LAWRENCE HISTORIC RESOURCES COMMISSION
ITEM NO. 2
STAFF REPORT

900 New Hampshire St; New Construction; Certified Local Government Review, Certificate of Appropriateness Review, and Downtown Urban Conservation Overlay District Review. The property is in the environs of Lawrence's Downtown Historic District and the North Rhode Island Historic District, National Register of Historic Places and within the Downtown Urban Conservation Overlay District. It is also in the environs of the Shalor Eldridge Residence (945 Rhode Island), Register of Historic Kansas Places and the Social Service League (905-907 Rhode Island), Lawrence Register of Historic Places. Submitted by Micah Kimball of Treanor Architects for 9th & New Hampshire LLC, property owner of record.

B. REVISED PROJECT DESCRIPTION

Revised Project Overview

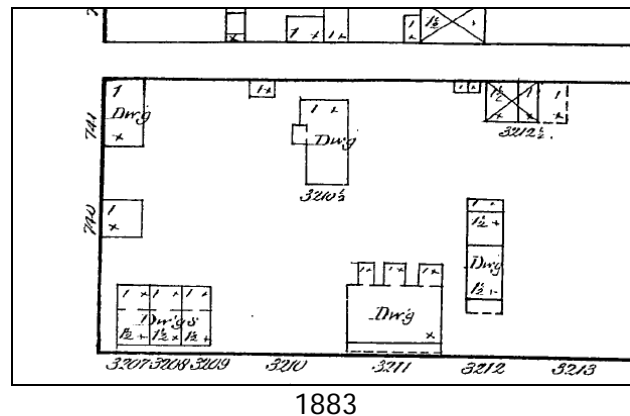
The proposed project is a multi-story mixed use building that includes two levels of underground parking, TownePlace Marriot extended stay hotel (90 units), a restaurant, and a ground floor retail space. The structure will be approximately 121,908 square feet with the hotel occupying part of the first floor, the second, third, and fourth floors. The restaurant will be located on the fifth floor. The proposed structure will be concrete and steel framed with materials that include stone, brick, and metal panels. The height of the structure at the corner of 9th and New Hampshire Streets will be 63'.

The proposed structure incorporates varying numbers of stories to address transitioning from New Hampshire Street and the commercial district to the North Rhode Island Street Residential Historic District. The height at the alley is 40' and the height at the Arts Center is 44'. Overhead doors are located on the north elevation to allow for access to the loading dock and the underground parking.

Storefront systems are located on the north and west elevations. Ground floor fenestration also includes the entrance to the building and to the hotel lobby.
